Appln No. 09/826,435

Reply to Office action of November 3, 2004

REMARKS/ARGUMENTS

FIG. 1a
 (PRIOR ART)

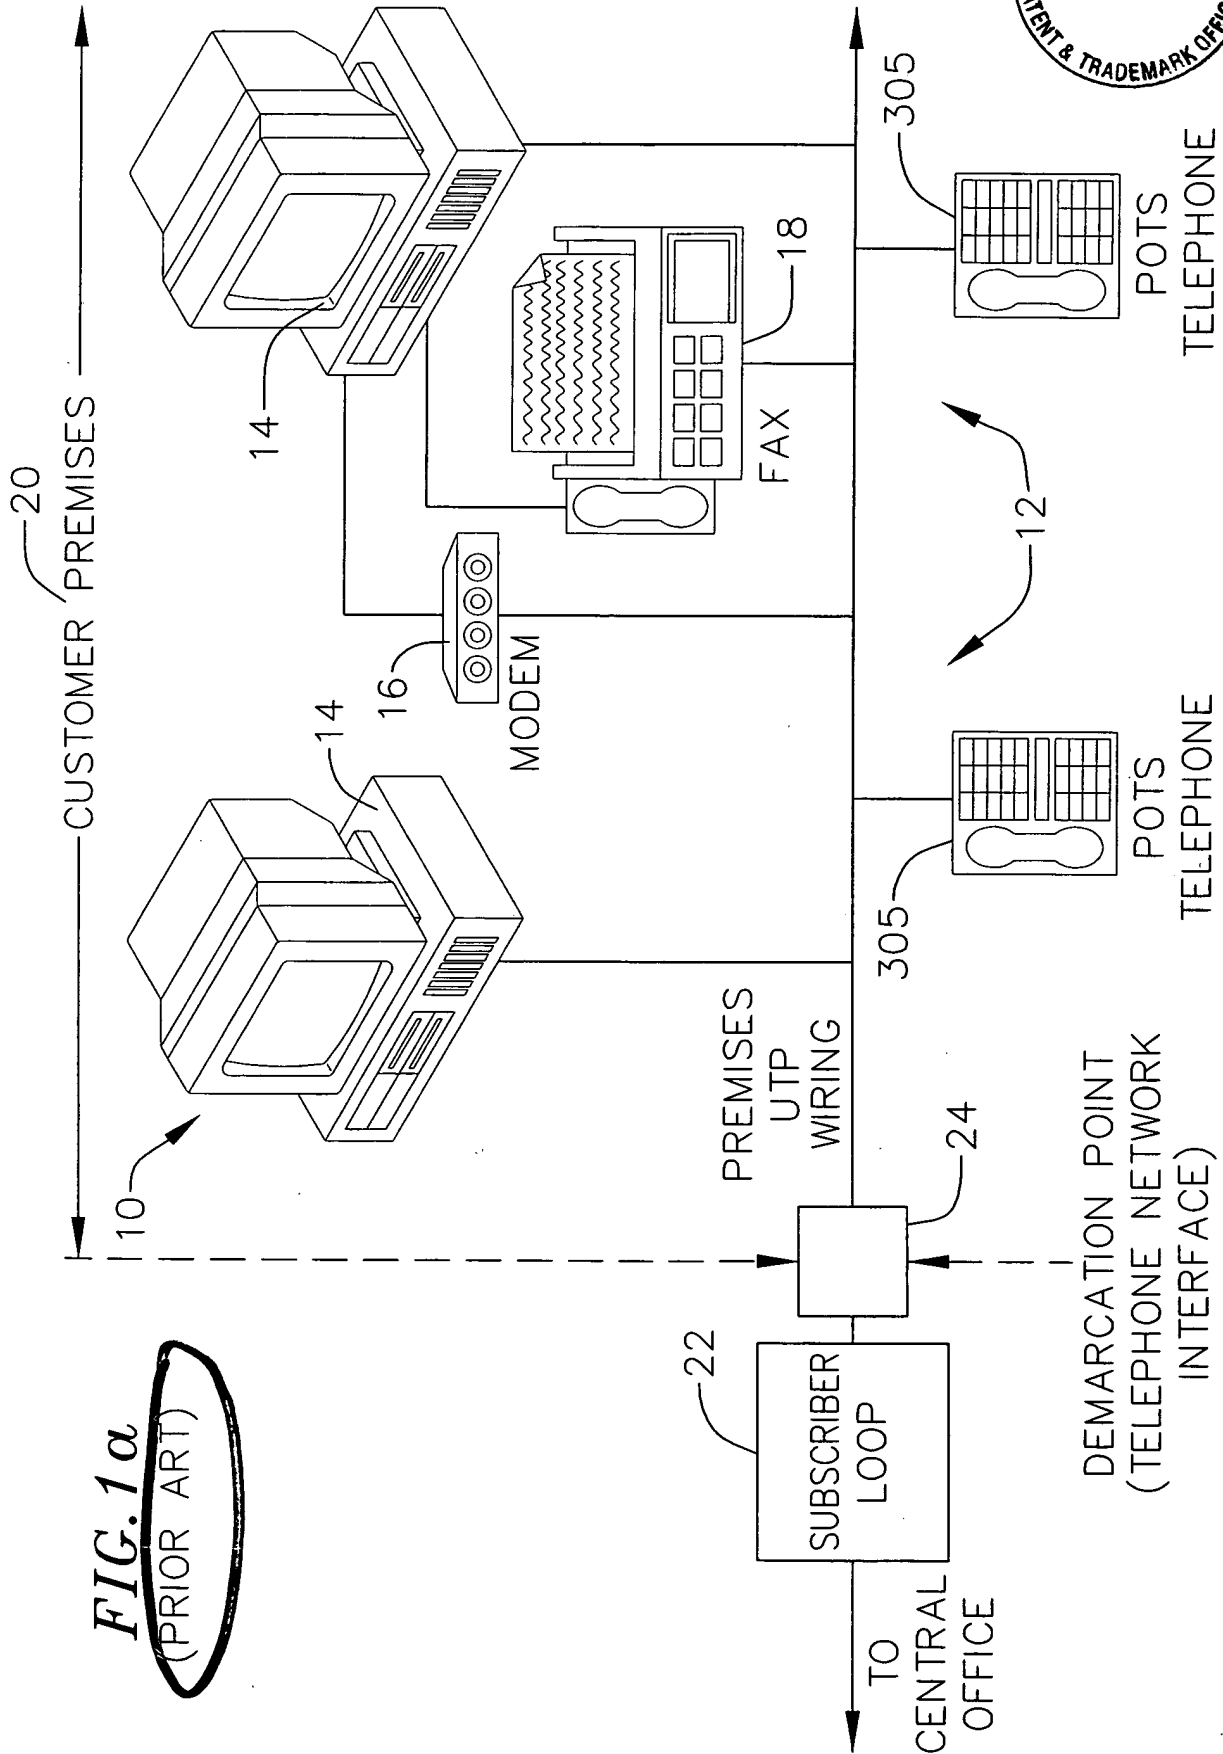
The Examiner has objected to the Drawings indicating that Figs. 1a - 1d should be labeled as prior art.

The Applicants have amended Figs. 1a - 1d accordingly.

replacement sheets of amended Figs 1(a) - 1(d), along with
annotated versions thereof, and
